# Technical Bulletin

Bulletin Number: 437 Revision Number: R-03

**SUBJECT:** SLIMLINE PLUG-IN BALLAST

**MODELS AFFECTED:** All models with Slimline Lighting

Figure 1

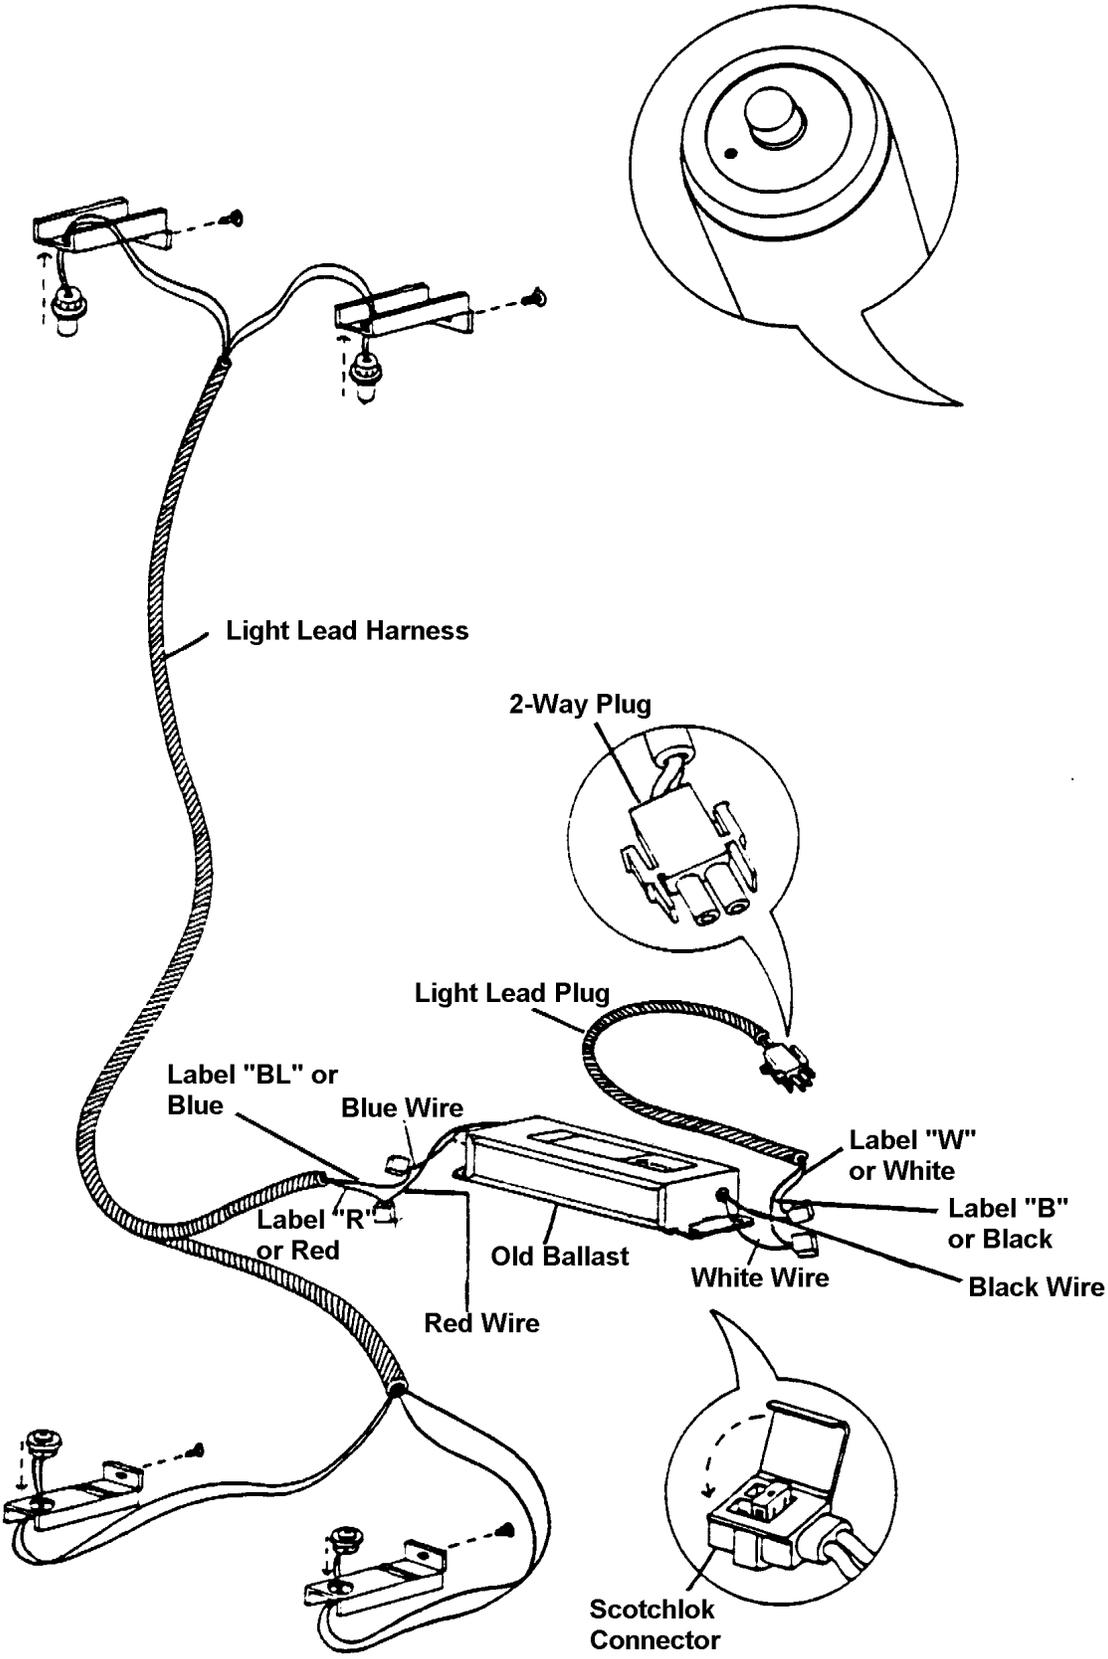
5. Once wires are labeled, disconnect the bad ballast at the scotchlok connectors. (See figure 1, page 3.)
6. To install the new Slimline Plug-In Ballast Retrofit Harness:

Figure 2

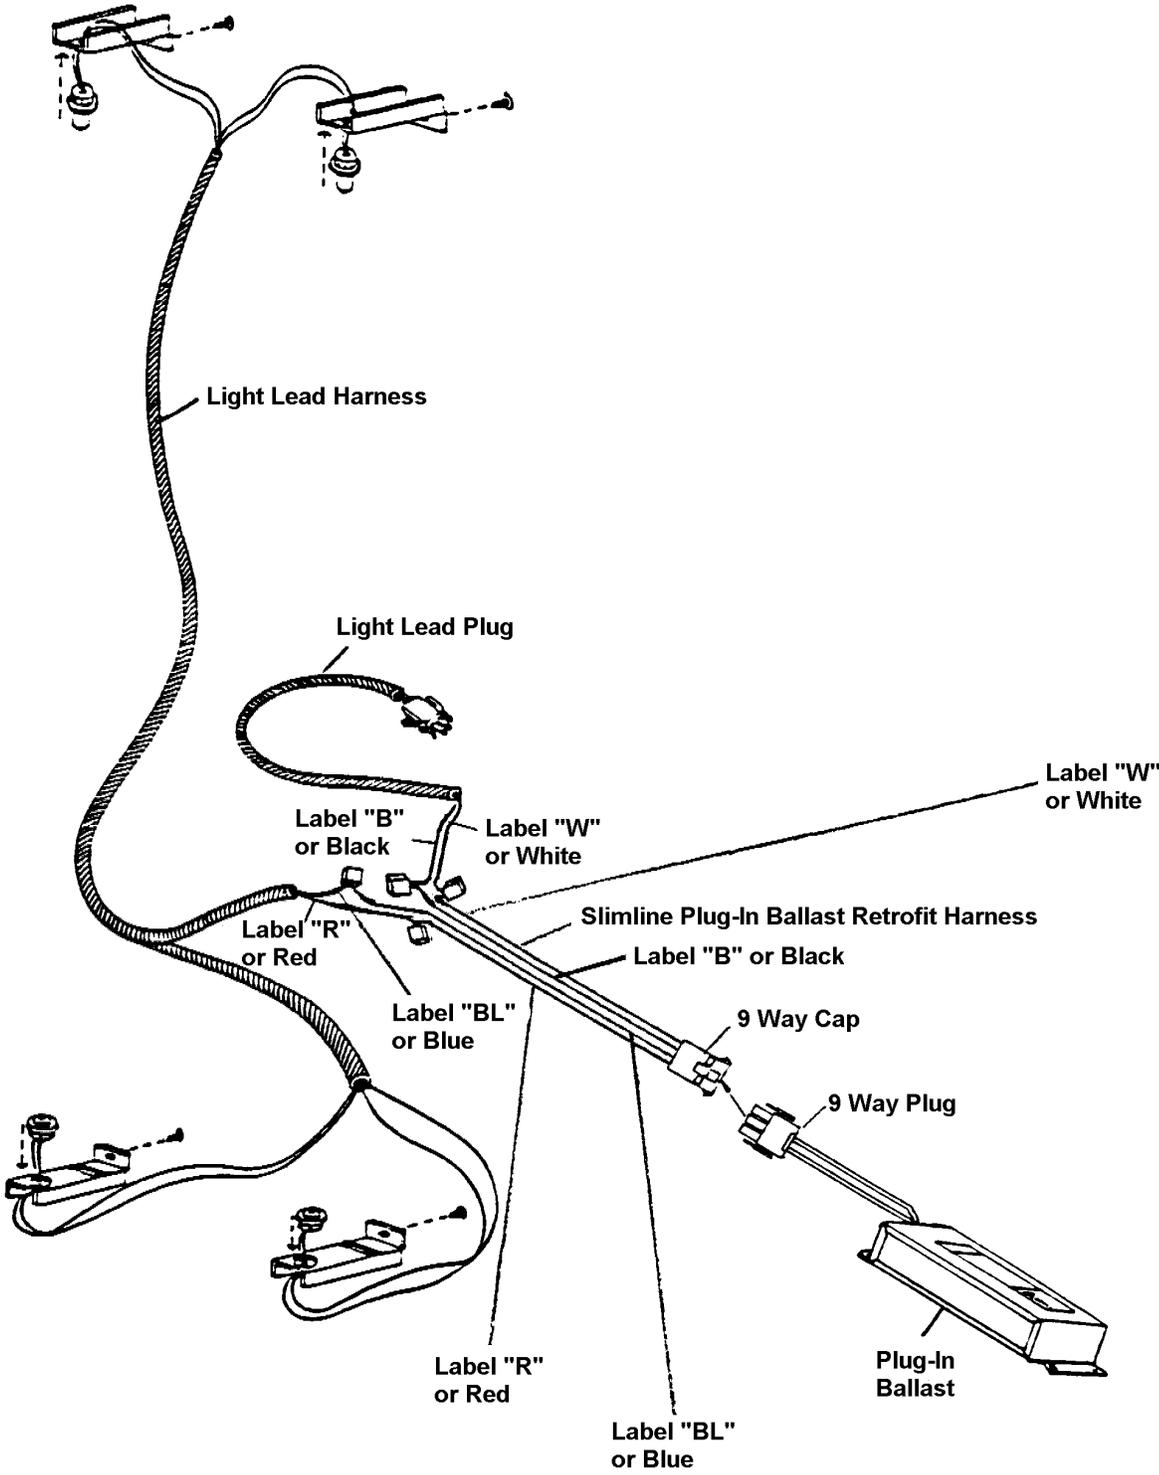
- A. Connect the wire of the light lead harness labeled "BL" (blue) to the wire of the Retrofit Harness labeled "BL" using a scotchlok connector. Tape the scotchlok connector with electrical tape, ensuring that the entire connector is completely covered. (See figure 2, page 4.)

- B. Connect the wire of the light lead harness labeled "R" (red) to the wire of the Retrofit Harness labeled "R" using a scotchlok connector. Tape the scotchlok connector with electrical tape, ensuring that the entire connector is completely covered. (See figure 2, page 4.)

- C. Connect the wire of the light lead plug labeled "B" (black) to the wire of the Retrofit Harness labeled "B" using a scotchlok connector. Tape the scotchlok connector with electrical tape, ensuring that the entire connector is completely covered. (See figure 2, page 4.)

- D. Connect the wire of the light lead plug labeled "W" (white) to the wire of the Retrofit Harness labeled "W" using a scotchlok connector. Tape the scotchlok connector with electrical tape, ensuring that the entire connector is completely covered. (See figure 2, page 4.)
